Planning Approval Consistency Assessment Form

Sydney Metro Integrated Management System (IMS)

| Assessment Name: | Spatial provision of Over Station Development retail within the station building |
| Planning approval: | SSI 15_7400 (C&SW) |

Attachment C: Additional retail spatial provisions within station building

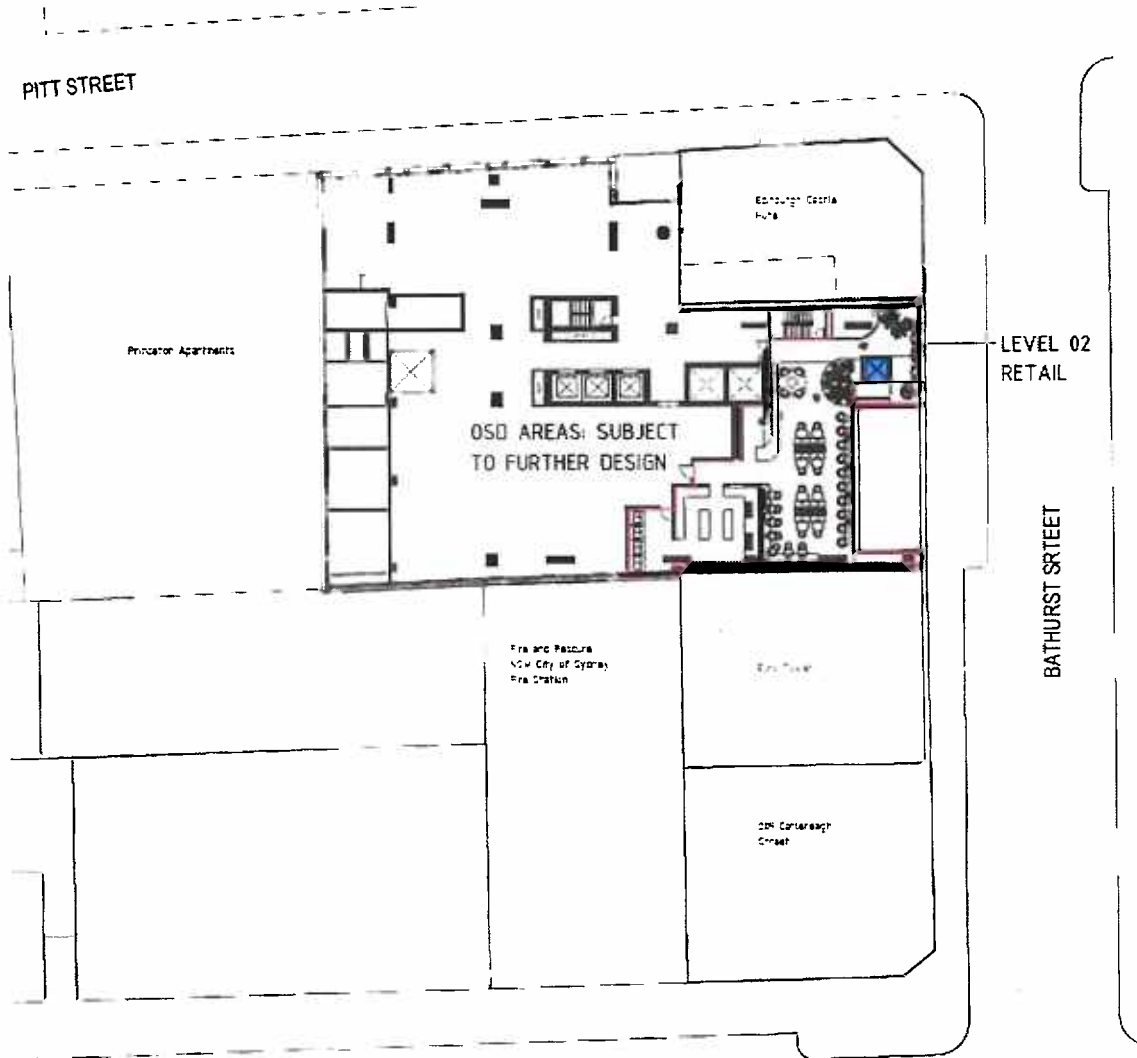
Since the EIS and PIR were prepared, the integration of the OSD and metro station elements at Pitt Street South has progressed through the design development process. A key feature of the integrated station design has been identification for additional spatial provisions of OSD retail within the station building structure and is the subject of this consistency assessment.

The relevant integrated station design drawings for the proposed works of this consistency assessment at Pitt Street South are included in **Attachment C** which details the extent of additional retail spatial provisioning within the station building.

The Pitt Street OSD site is relatively constrained, and there is not a lot of space at ground level to provide for activation and placemaking opportunities in addition to the station entry and concourse area. Through additional design work, an opportunity has been identified to provide an additional retail space on Level 2 to accommodate a proposed bar/restaurant, which would support activation and placemaking outcomes at Pitt Street South. This Consistency Assessment (CA) is to address the consistency of the proposed design change with the existing CSSI Approval (i.e. addresses the additional spatial provisions to support the OSD retail opportunity identified as part of the design development of the integrated station development. It is noted that separate approval would be required for the fitout and use of this space.

| Aspect | Nature and extent of impacts (negative and positive) during construction (if control measures implemented) of the proposed/activity, relative to the Approved Project | Proposed Control Measures in addition to project COA and REMMs | Minimal Impact Y/N | Endorsed | |
|--------------|--|--|--------------------|----------|----------|
| Visual | No change from approved project, other than additional spatial provision for retail within Level 2 of the station building. However, as proposed in the EIS and clarified in the PIR, the Pitt Street station portals were intended to integrate with a development over the station (OSD) and subject to design development. Therefore, the identification of additional retail space provisioning as a result of design development falls under the existing CSSI Approval. | No additional measures required. | Y | Y | — |
